# **Structural Damage Prediction and Analysis for Hypervelocity Impact**

# **HYPERVELOCITY IMPACT STUDY CONSULTING**

Subject: SD\_SURF Conclusions

**Subject: Number of Elements Required to Make a BUMPER Model.**

ENCLOSURE 1

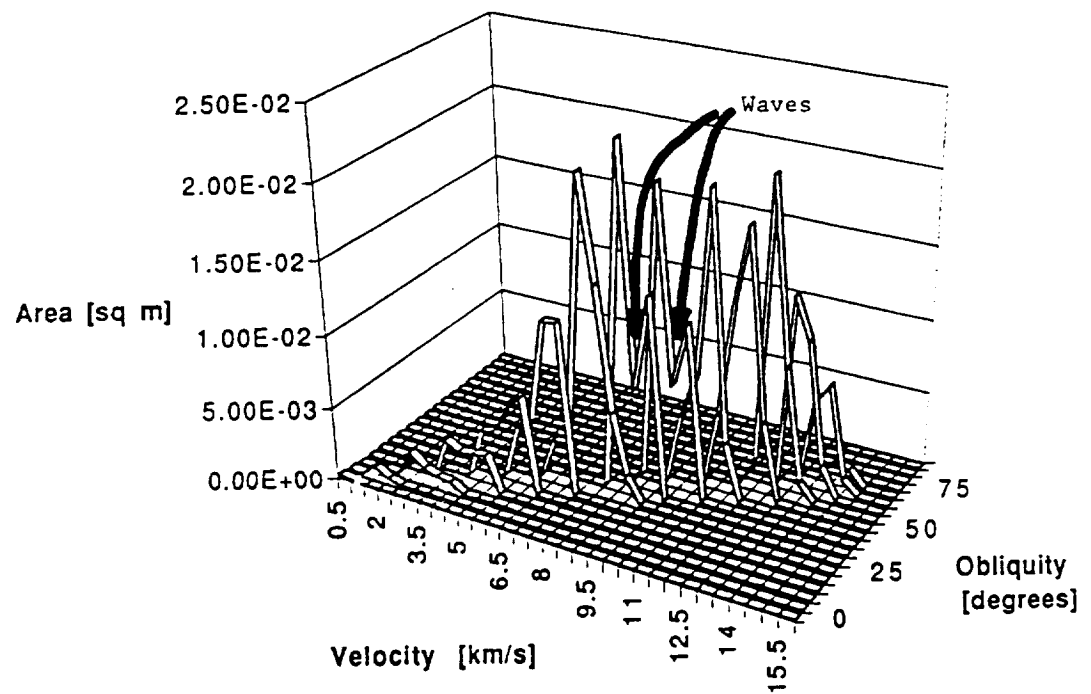
These conclusions were in part based on the analysis of the effective area of a flat plate whose normal points in the direction of the y-axis. These SD\_SURF results are shown plotted in Enclosure 1. The objectionable features of these plots are the waves on the surface labeled "waves" in Enclosure 1. The author of the reference was only able to smooth out the waves in the SD\_SURF plots when the GEOMETRY model of a curved surface target used facets which subtended an angle of less than 5° (Conclusion 1) and numbers of threats equal to 68 (Conclusion 2).

EXAMPLE OF WAVES WHICH APPEAR ON AN SD\_SURF PLOT OF  
A RUMPER GEOMETRY FILE.

The "wave" issue was not meant to be a criteria for judging an analysis, but rather a guide for understanding how the ballistic limit surface was being queried by the GEOMETRY output and the overall effect on PNP. The SD\_SURF output shows which velocities and obliquities influence the overall PNP.

The missing word was "more," and it was used in relation to SD\_SURF. This was only meant to be a relative comparison between the two programs. The programs will produce slightly different results that are negligible for the ballistic limit surfaces we have dealt with. The remark addressed the angle subtended by a facet used to represent a curved surface. The remark was meant to quantify a situation where the BUMPERII result would be more accurate, **if** there was a significant difference in the results. The point of the statement was that SD\_SURF overall probability calculations may be used as confidently as BUMPERII for models that have coarser increments than 5° facets and 90 threat directions, regardless of the ballistic limit surface. Finer models are prohibitively time consuming and will not necessarily produce a different result.

ENCLOSURE 2

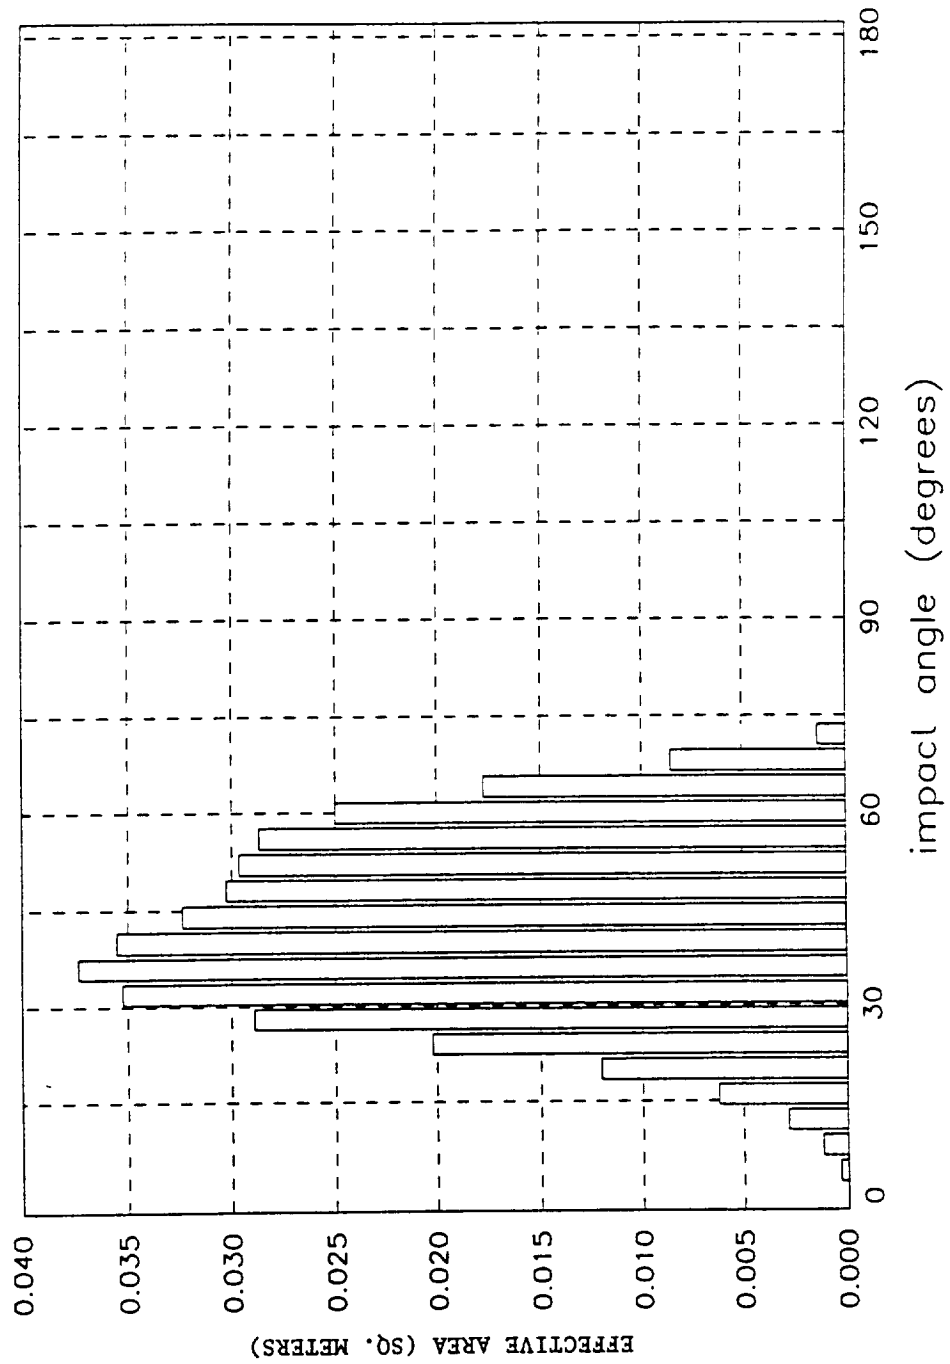
The author of the present memo was unaware of ever having seen the waves of References 1 and 2 before. To illustrate this, the problem of Enclosure 1 was calculated and plotted by the present author in Enclosure 2. Note that there are no waves and the trends are smoother but somewhat similar to those of Enclosure 1.

EFFECTIVE AREAS CALCULATED WITH BUMPER. NOTE THAT THE PLOT IS SMOOTH WITH NO "WAVES".

ENCLOSURE 3

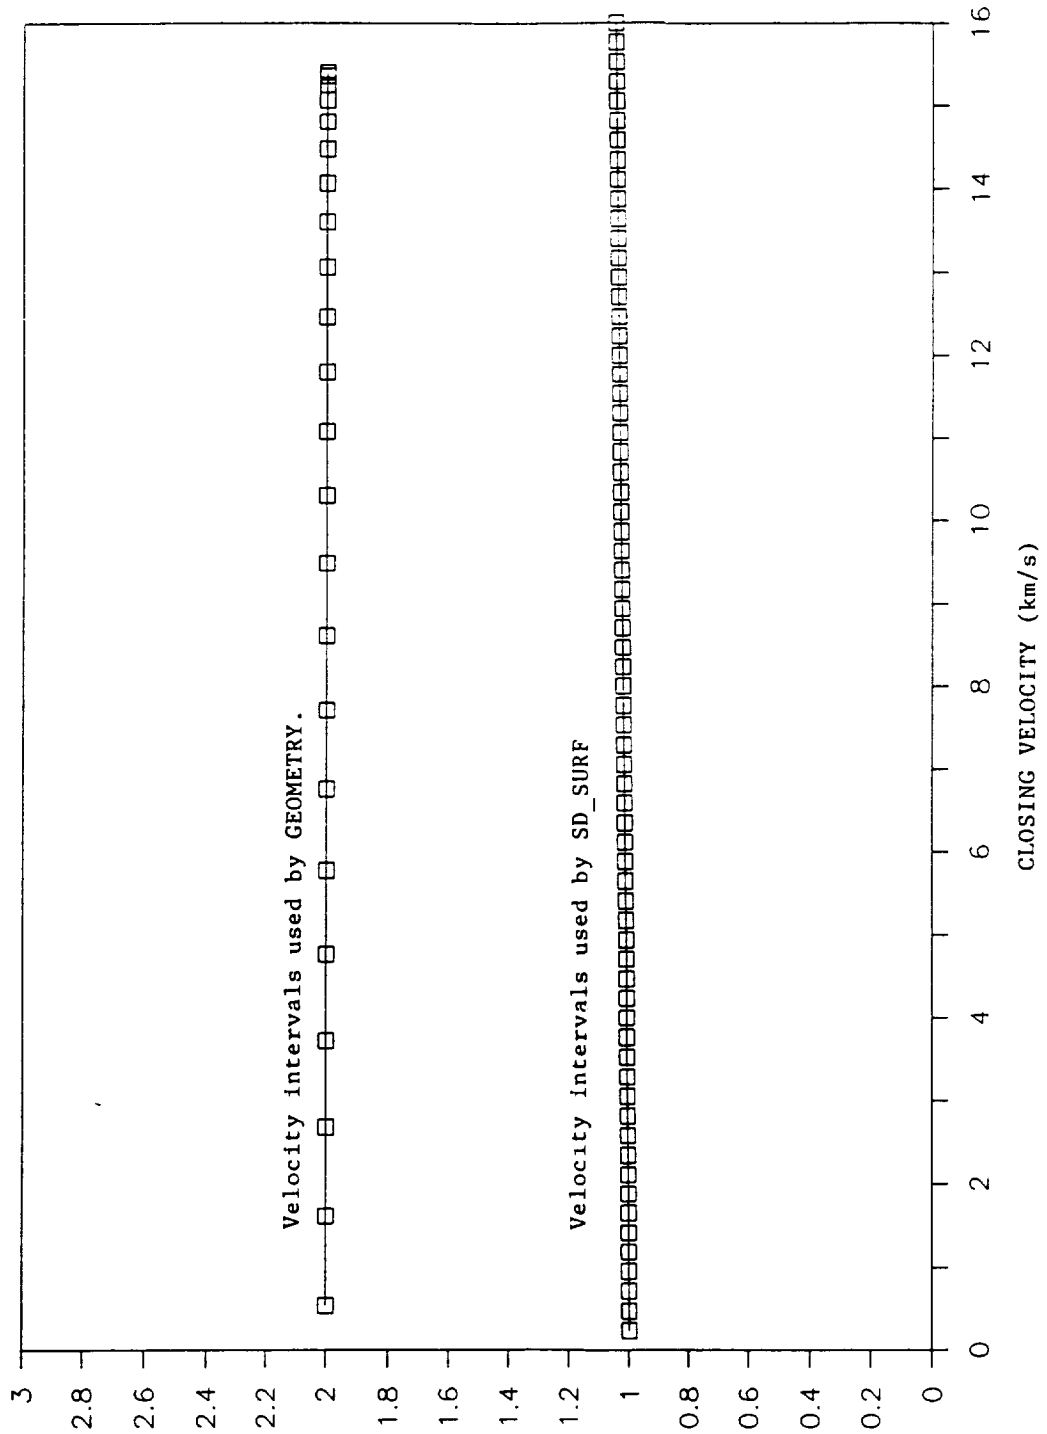
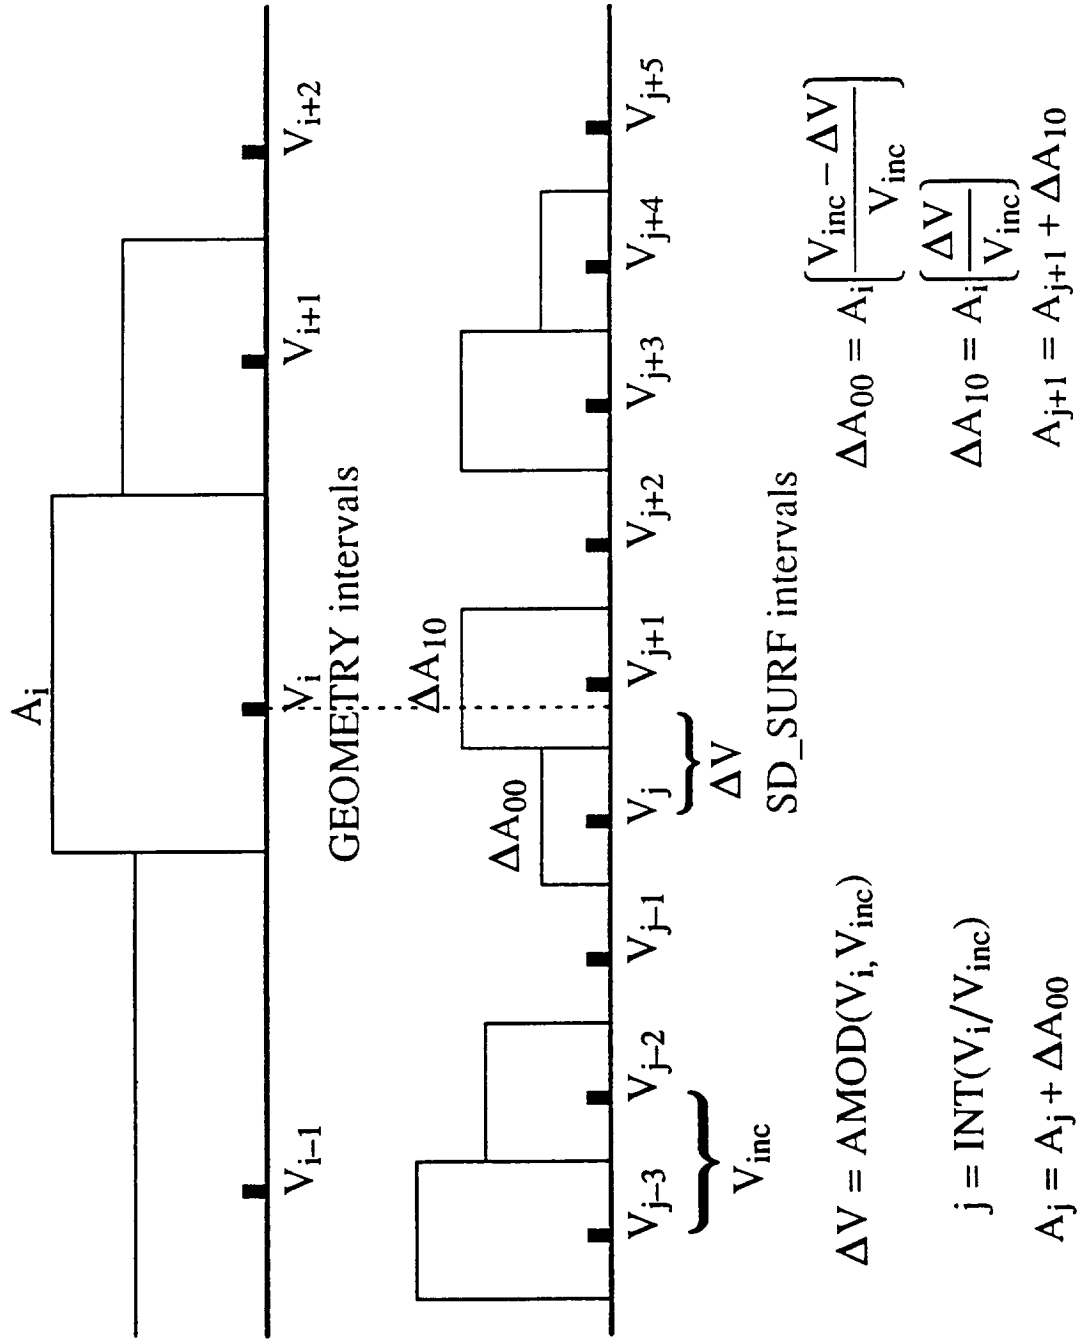
unequal spacing of the threats in velocity space, See Enclosure 3 top row of squares. The 3d plotting routine used by EXCEL required evenly spaced intervals of velocity. The intervals used by SD\_SURF are illustrated by the bottom row of squares in Enclosure 3. Note that for small closing velocities there are many SD\_SURF intervals for one GEOMETRY interval.

COMPARISON OF THE SIZE OF THE VELOCITY INTERVALS USED BY THE GEOMETRY PREPROCESSOR FOR BUMPER WITH THE VELOCITY INTERVALS USED FOR PLOTTING BY SD\_SURF.

Your enclosures 4 and 5 give the false impression that BUMPERII averages over the the entire velocity range associated with each threat. In actual fact BUMPERII uses only a single velocity for each threat as shown in your enclosure 3. BUMPERII does not know what happens to the ballistic limit surface between each calculated threat velocity.

ENCLOSURE 6

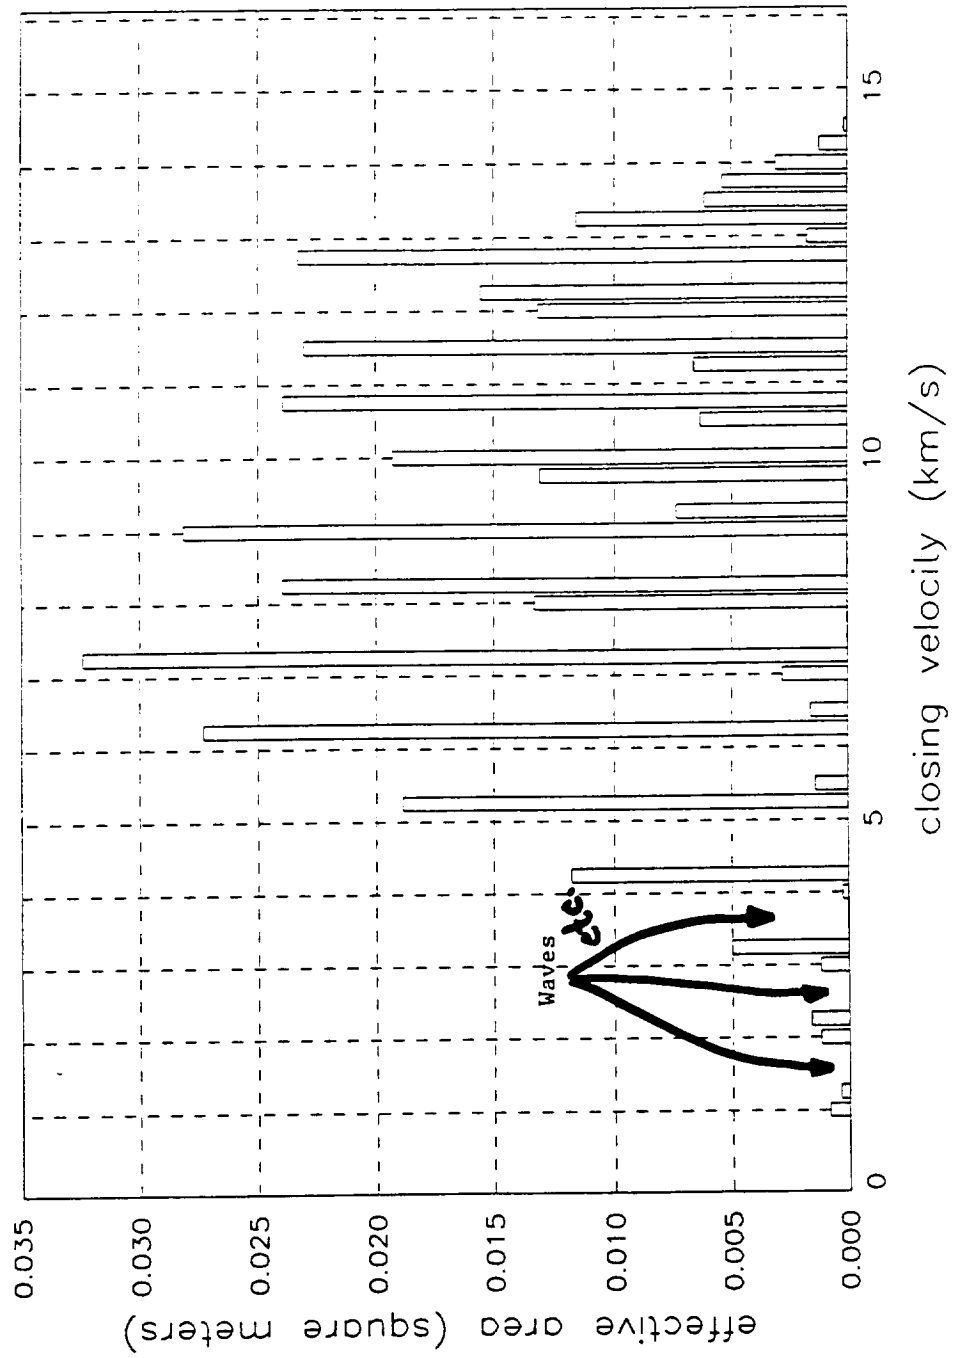
The one dimensional analog of the algorithm used by SD\_SURF to distribute effective area belonging to the unequally spaced GEOMETRY intervals over the equally spaced SD\_SURF intervals is illustrated in Enclosure 4. Note that the SD\_SURF algorithm introduces large gaps in the plot by assigning all of GEOMETRY effective area to the SD\_SURF interval nearest the center of the GEOMETRY interval. Thus, if there are many SD\_SURF intervals per GEOMETRY interval some of the SD\_SURF intervals will never get an effective area assigned to them. That is, waves on the results will appear. To illustrate the effect, the effective area calculation for the flat plate of Enclosure 1 and 2 was plotted in Enclosure 5 using the GEOMETRY intervals. The SD SURF algorithm was used to replot the data on evenly spaced intervals in Enclosure 6. Note the waves.

THE SAME DATA AS ENCLOSURE 5 PLOTTED WITH THE SD\_SURF ALGORITHM. NOTE THAT THE SD\_SURF PLOTTING ALGORITHM HAS INTRODUCED "WAVES" INTO THE PLOT.
